New functions and addendum

- This document contains descriptions of how to set the new functions and their restrictions. Refer also to the Operating Instructions of this product.
- Depending on the model used, the screens shown in the explanations may differ to the actual camera screens.
- This document is for the following models.
WV-S1572L, WV-S2572L, WV-S2272L, WV-S1552L, WV-S2552L, WV-S2252L

•Firmware Ver.1.50

5. Extend authentication password for the destination of notification (Operating Instructions – Configure the network settings [Network] – Configure advanced network settings [Advanced] - Configure the settings related to sending E-mails)

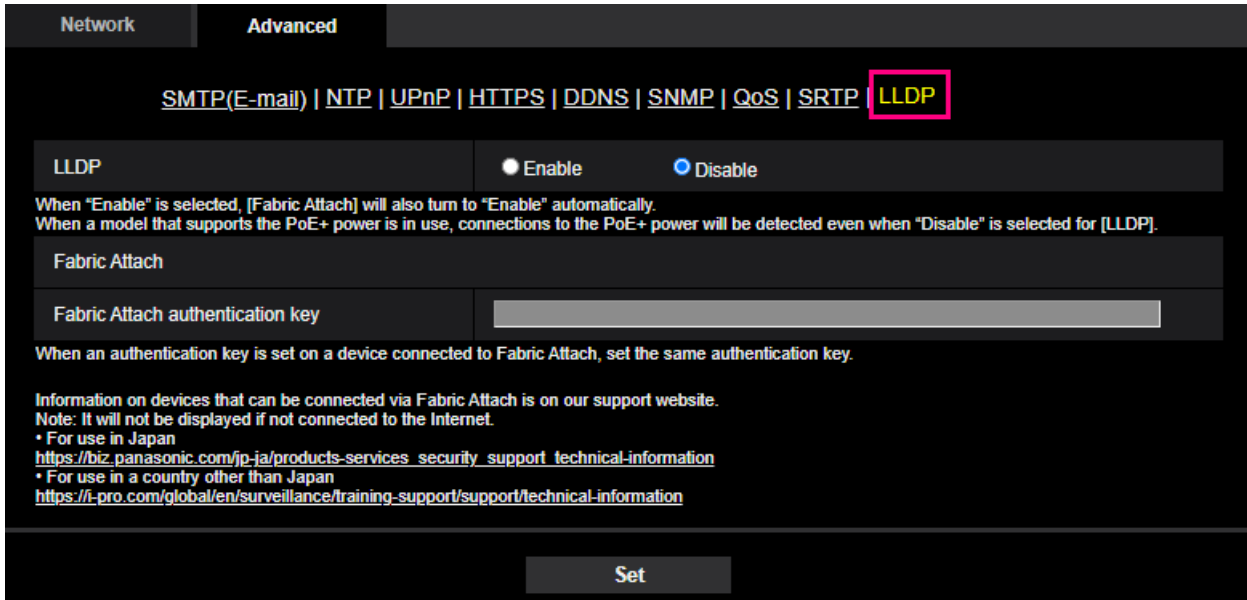
The number of characters that can be entered for the authentication password of the destination of notification has been expanded to 128 characters.

- **[Authentication – Password]**

Available number of characters: 0 - 128 characters

Unavailable characters: " &
